July 31, 2009
TMI-09-097

**SUBJECT: THREE MILE ISLAND NUCLEAR STATION UNIT 1 AND UNIT 2
OPERATING LICENSE NO. DPR-50 AND POSSESSION ONLY LICENSE NO. DPR 73
DOCKET NOS. 50-289 AND 50-320
SUPPLEMENT TO COMBINED 2008 ANNUAL RADIOACTIVE EFFLUENT
RELEASE REPORT**

**ODCM change for
TMI Offsite Dose Calculation Manual, Revision 1
CY-TM-170-300**

FIGURE 3.1
TMI-1 Liquid Radwaste

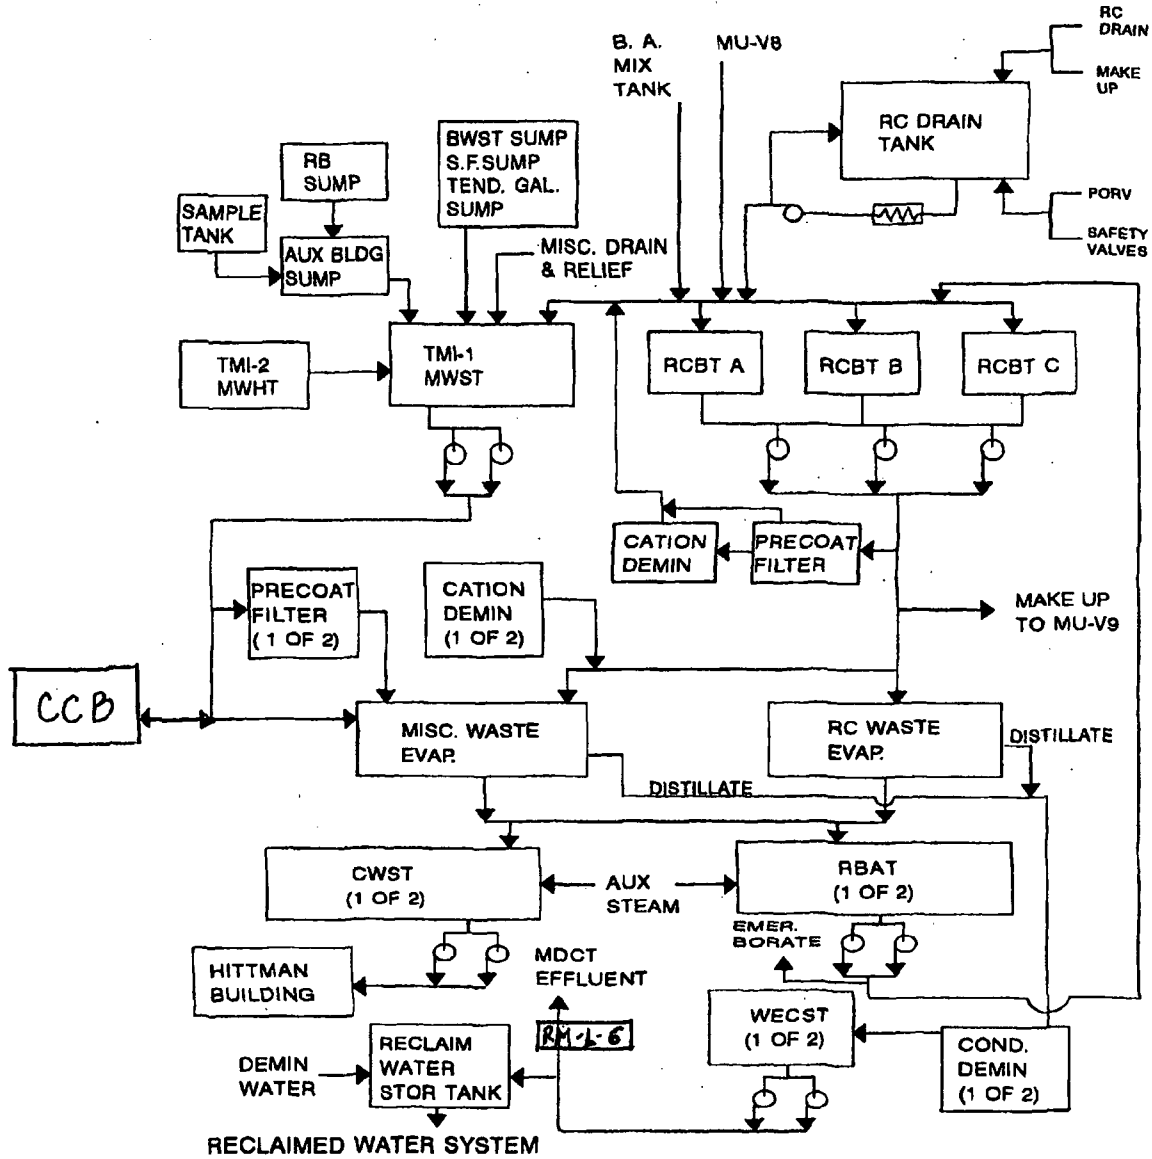
Figure 3.1 is being revised to include pathway to the Chemical Cleaning Building (CCB) and RM-L-6 monitor for liquid radwaste processing. In section 2.2.1.1, DAC is being changed back to MPC. In Table 3.1-2, the note regarding RM-A-7 operability is being clarified. Equation 4.2 is being updated to include Sr-90 for particulate monitor setpoints.

During a walkdown with the NRC during an inspection, it was identified the path to the CCB for the radwaste system and RM-L-6 were not reflected on Figure 3.1. (IR 794671) The reference to MPC in section 2.2.1.1 needs to remain to be consistent with the ICRP 2 reference. (IR 794799) The note clarification in Table 3.1-2 is being made to make it consistent to Table 2.1-2. (IR 757133) The concentration definition for equation 4-2 in section 4.2, needs to be updated to reference I-131 for radioiodine monitors and Sr-90 for particulate monitors. (IR 795519)

Updating Figure 3.1 will have the figure reflect the current configuration in the plant and on plant drawings. Changing the reference back to MPC will maintain consistency between the references in the basis. Clarifying the note in Table 3.1-2 and making it consistent with Table 2.1-2 will improve human performance. Particulate monitor setpoints are currently set using Sr-90 so there is no impact to the plant.
